**PRIVATE HARDSTANDING AS
BUILT APPRAISAL REPORT
PHASE 9 STONEHAM, EASTLEIGH**

PROJECT NAME: Phase 9 Stoneham, Eastleigh
PROJECT NUMBER: 5020063
DOCUMENT REFERENCE: 5020063-RDG-XX-XX-DOC-C-S22-3008
DOCUMENT STATUS: S2 – Suitable for Information

This private hardstanding as-built appraisal report has been prepared on behalf of Highwood Group Limited for a completed development at North Stoneham Park, located off Chestnut Avenue, Eastleigh, SO50 9RU (hereby referred to as the 'Constructed Site').

Photo 51 – Private Lighting Column

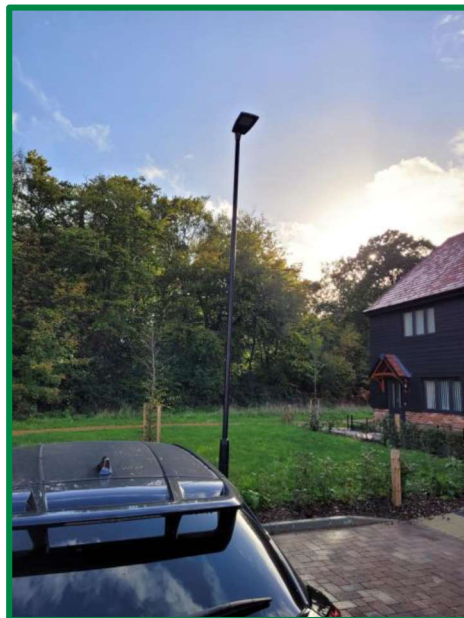
Private lighting columns and illuminated bollards could be seen through the private parking areas, roads and drives although these were not explicitly shown on the supplied plans. The lighting columns seemed to be of a similar specification to the lighting columns in the adopted/adoptable highway and offer a betterment to the unlit lighting arrangement presented in the Construction Make Up Plans (19-308 029-31).

Photo 55 – Parking Space Numbering

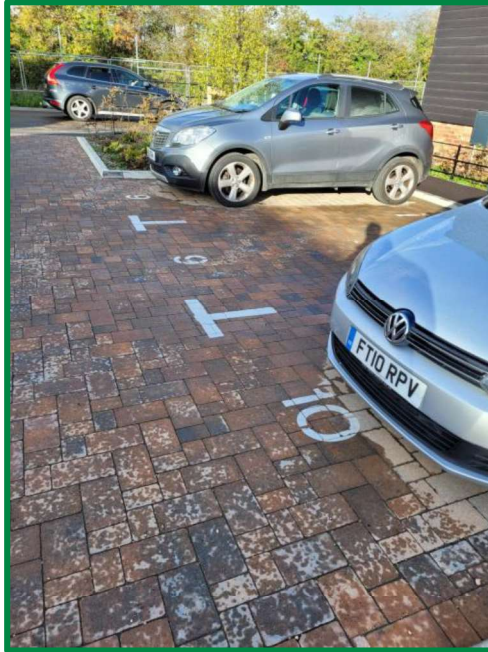
The numbering of the parking on site was found within the parking space spaces, including visitor locations and locations for local residents to use. The correct quantity of spaces has been provided as per the approved plans. The dimensions of the parking spaces were also consistent with those specified on the approved layout.

Photo 49 – Paving Slab Cutting

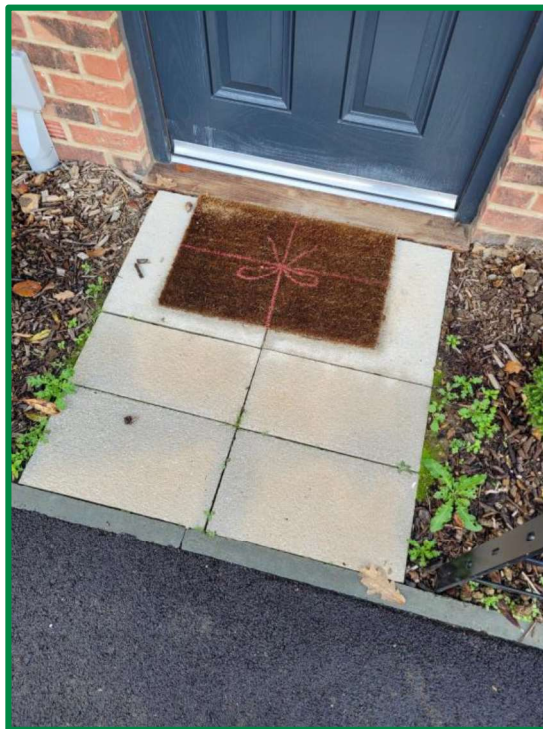
Block paving and paving slabs were laid throughout the site in the correctly specified locations and were as per the approved materials. No sign of wear or cracking of private paving was detected during the site visit and all slabs were cut in a clean manner.

Photo 41 – Gully Gratings Installed

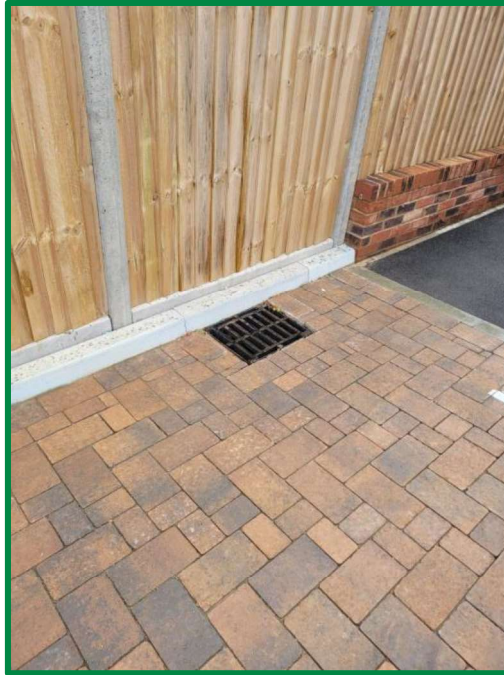
The gully gratings installed in the shared surface areas did not appear to be of a pedestrian friendly nature, there is therefore the potential for shoes to get caught in the slots of the grating and for personal items to fall through the slots into the sump below. Although generally the gullies were small in nature it may be prudent to replace the gratings where they are present in close proximity to pedestrian trafficked routes to avoid injury/loss of property.

Photo 17 – Flush Kerb onto Private Hardstanding

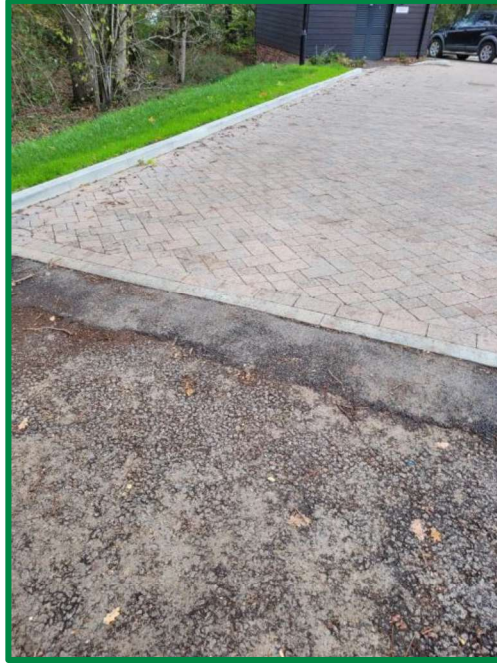
On a number of transitions between adoptable/adopted highway and private drives/roads a flush kerb was present without any intercepting drainage feature, this will encourage highway runoff onto private areas. To remedy this, upstands should be installed with a drainage feature to ensure that runoff is disposed of appropriately.

Photo 26 – Path Passing Through the Woods

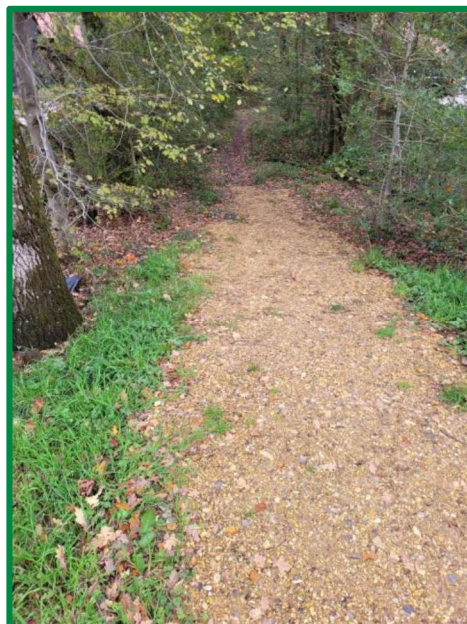
The path passing through the woods on the opposite side of the road to plots 30-38 does not benefit from dropped kerbs. The path through the woods has been laid in a natural gravel finish with a slightly sloping gradient, this should be seen as a vast improvement over the previous arrangement which had unnecessary steps, corduroys and handrails. The new arrangement allows for easy access for cyclists, prams and pedestrians as was observed during the survey.

Photo 4 – Plots 58-65 Rear Access

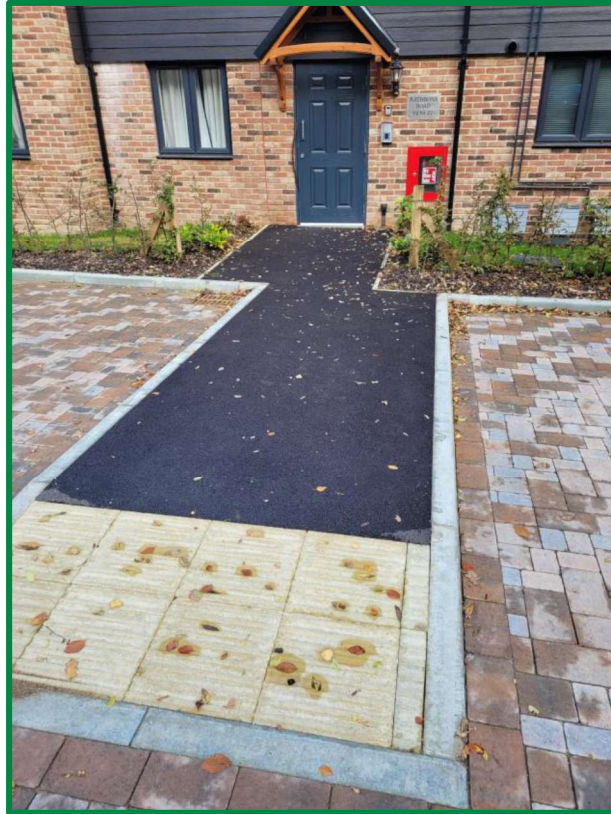
The rear access to plots 58-65 differs from the arrangement shown on the layout as the path is wider (1.65m) but contains a small deviation which is not shown on the plans. Although this is the case, the 1.2m wide margin is still maintained at the narrow point and the entrance still meets all grading requirements as per Approved Document M.

SURVEY MARK UP LAYOUTS

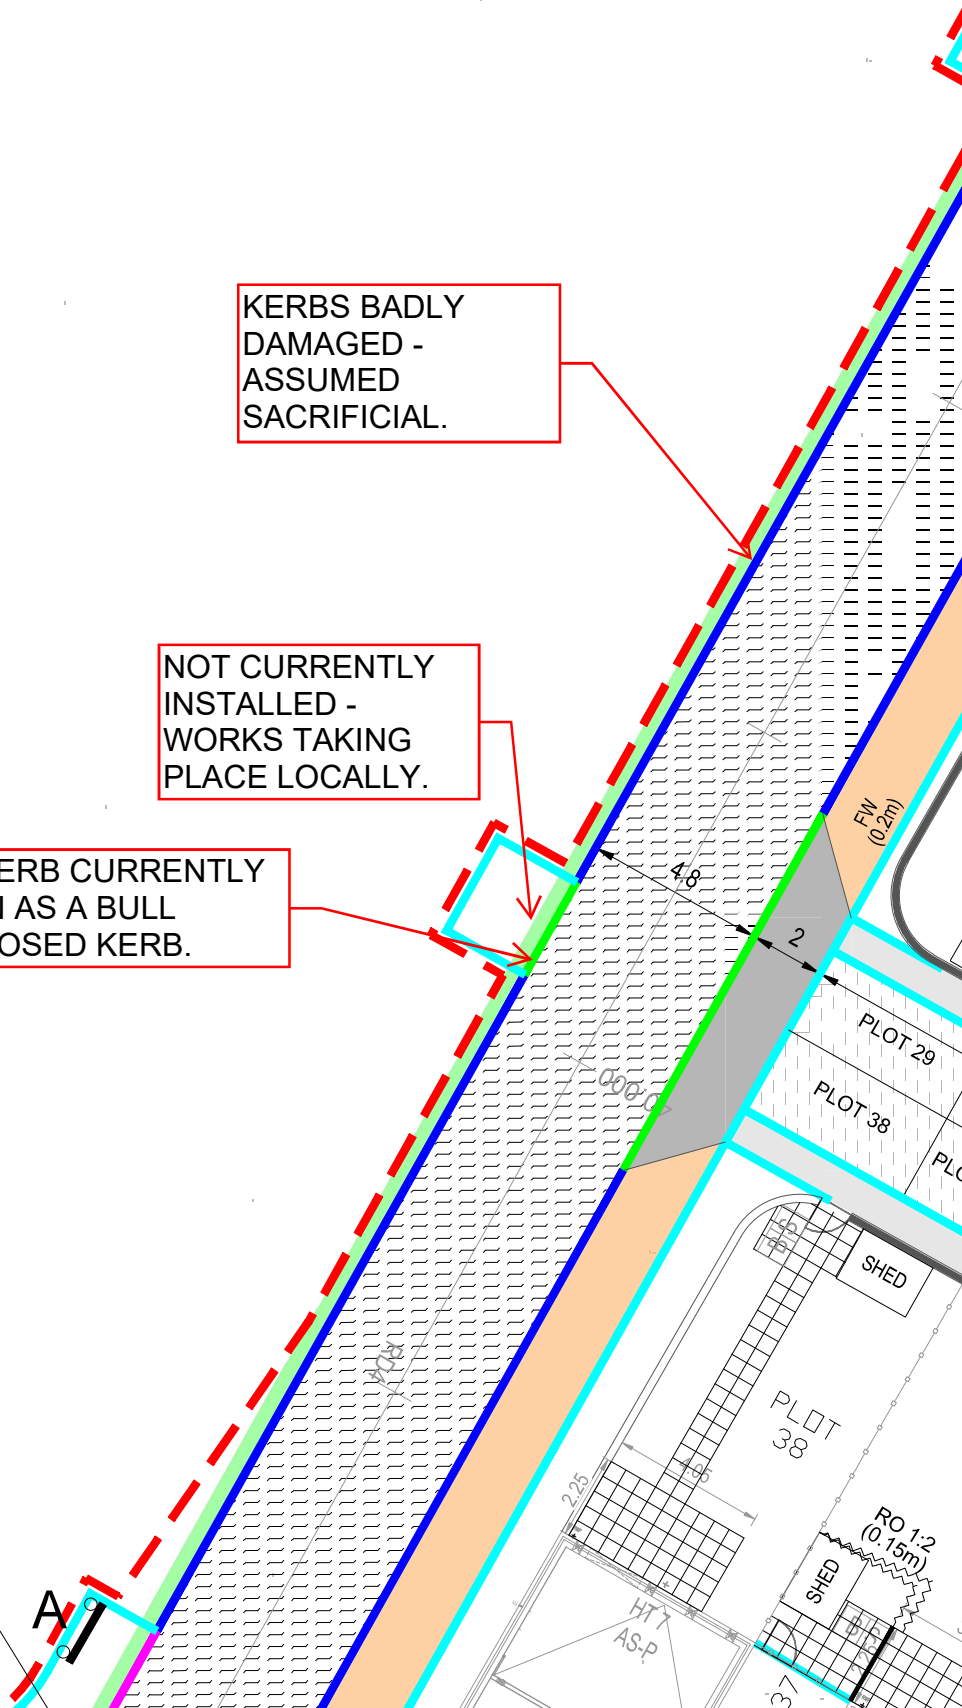
NO EDGING.

KERBS BADLY
DAMAGED -
ASSUMED
SACRIFICIAL.

NOT CURRENTLY
INSTALLED -
WORKS TAKING
PLACE LOCALLY.

KERB CURRENTLY
IN AS A BULL
NOSED KERB.

BUILDING DEBRIS
LEFT IN DITCH.

SOME PLOTS ONLY
GET A SPACE
SOME GET TWO -
OWING TO
NUMBER OF
BEDROOMS?

8.2 X CORDUROY'S
NOT NINE.

Photo 32

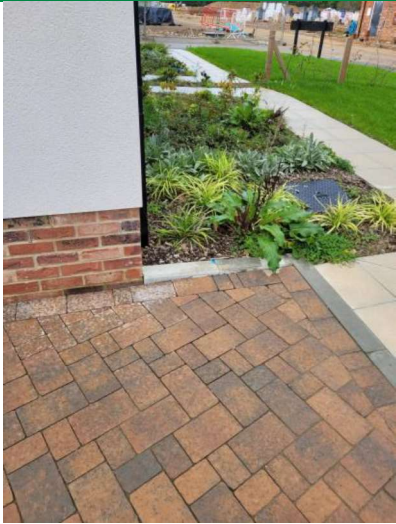
In some instances, the incorrect kerbs were installed which were not appropriate for the location, however, the difference was of little significance and would not present a hazard to pedestrians and disabled users. Additional edgings were installed in multiple locations against the sides of properties; however, this treatment was not shown on the layout. This actually represents an improvement as it provides the surfacer/groundworker with a clean edge with which to lay asphalt, therefore this does should not be a cause for concern. Some edgings were omitted in areas, for example to the side of plot 5's parking, however, the contribution from these edgings would not have been meaningful and therefore their omission is of little consequence. In some instances, full height kerbs have been specified on the layout, despite these kerbs leading onto pedestrian areas, notably, at the crossing through the woods in front of plot 37 and at the visitor parking in front of plot 34, this could present a trip hazard and consideration should be given to replacing these kerbs with pedestrian friendly alternatives.
